SUBJECT: Site Plan Review for Hudson Crossing Parkway – Spec industrial building at Parcel #3009750

PC Case No: 2016-19

RE: PC 2016-19-Site Plan Review for Hudson Crossing – 125,000 square foot spec building

Date: July 7, 2016
To: Greg Hannan, City Planner, Community Development
From: Thomas J. Sheridan, P.E., P.S., City Engineer
Re: **Hudson Crossing Site Plan Review**

**STORM WATER
MANAGEMENT BASIN
PLAN**

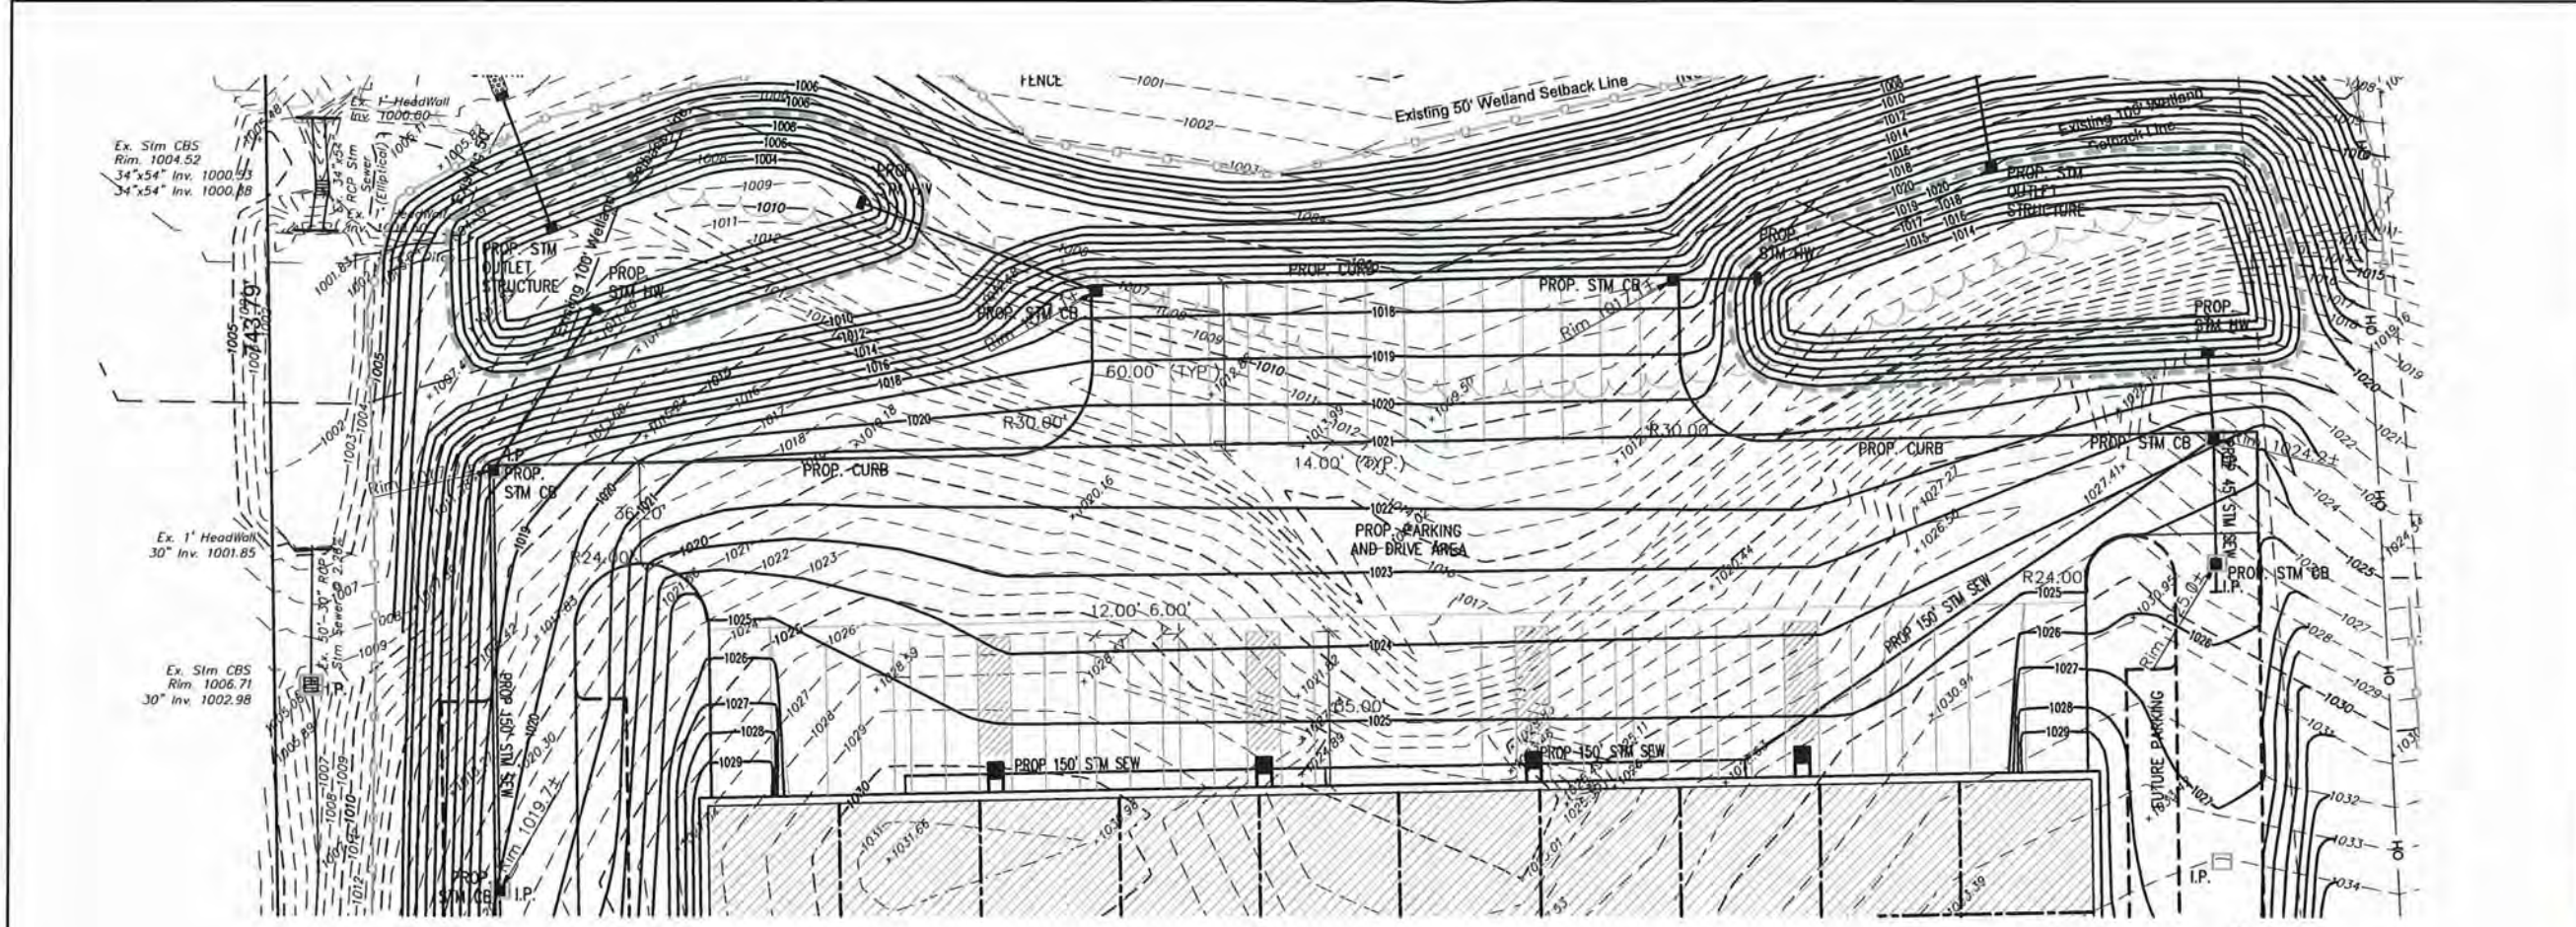
- No major issues with the preliminary site plan.
- The storm water management calculations shall be submitted for review or a letter from the professional engineer performing the site plan design shall review the existing overall development storm water management plan, if this site was included in the original design.
- The City will perform a full review of the plans when the final site plans are submitted.
